Response to the interactive comment on “Distributed summer air temperatures across mountain glaciers: climatic sensitivity and glacier size” by Thomas E. Shaw et al.

Referee #2 - Luca Carturan

Received and published: 14 November 2020

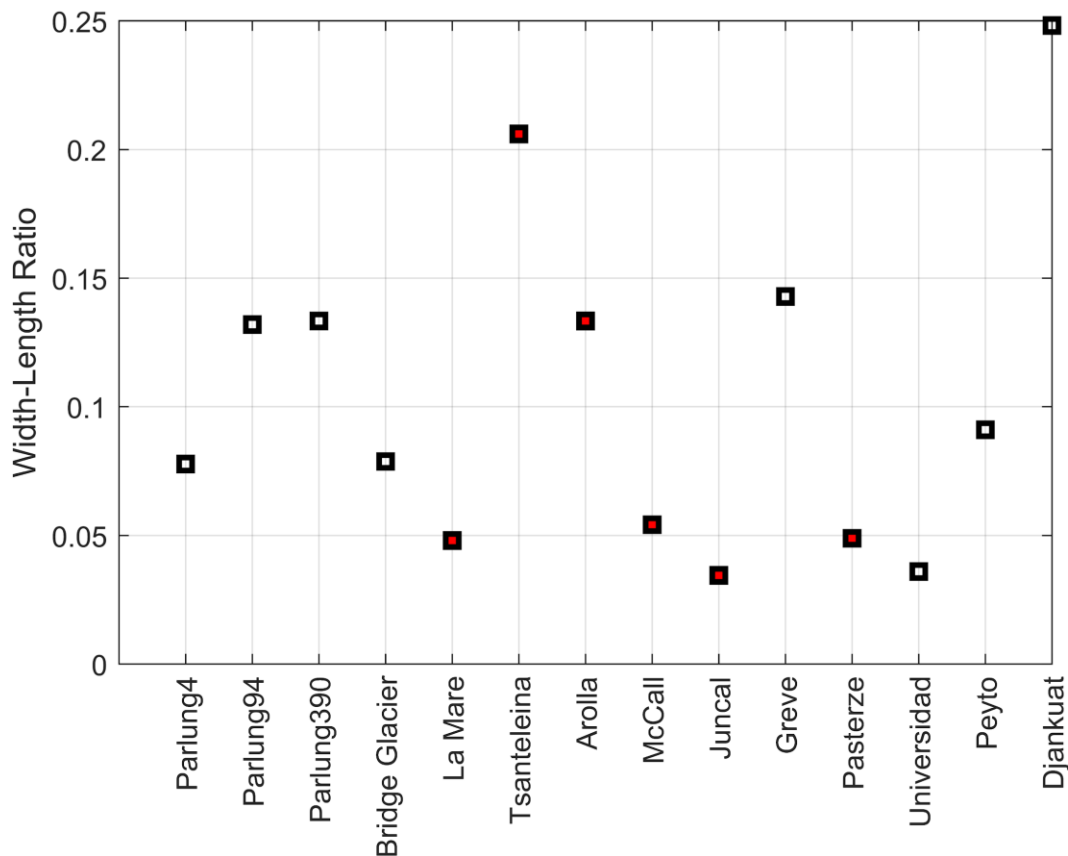
388-396: these results are interesting, and I wonder if there can be some influence from the very low width/length ratio of the tongues of McCall and Juncal Norte, surrounded by ice-free slopes that are expected to warm considerably... Parlung4 instead has a more 'compact' shape (i.e. less thin and long tongue). In addition I ask the authors to consider possible differences in the sensors and radiation shields used in the various referenced works and datasets (e.g. the radiation shields used in Juncal Norte were PVC cylinders opened at both ends, that are very different from the generally-used multi-plate radiation shield)

This is a very interesting idea and we thank the reviewer for suggesting it! While we believe that the very distinct behaviour for Juncal Norte (Fig 8) is a result of the up-glacier wind during the warmest hours (Pellicciotti et al., 2008; Petersen and Pellicciotti, 2011), the reviewers' suggestion of valley confinement and the influence of warming slope could have an influence. We measured an approximate width of each glacier from Google Earth (not on the exact date for each dataset, but still providing a general idea), taking the average width over the lower ~30% of the glacier (i.e. Figure 10). We show below (in Figure R1) the ratio of this width to the total glacier length, where the coloured boxes are those sites grouped as showing increased temperature sensitivity (as in Figure 10). It suggests that many sites with thin tongues have evidence of this increased sensitivity (as suggested by the reviewer), though there is not a clear pattern for those sites without the increasing temperature sensitivity (hollow boxes in the figure below). The degree to which the glacier tongue is constrained by the valley may likely play a role through longwave emission as well as controlling exposure to synoptic winds etc. We have now included more discussion on this in the manuscript as well as adding the figure below to the supplementary material.
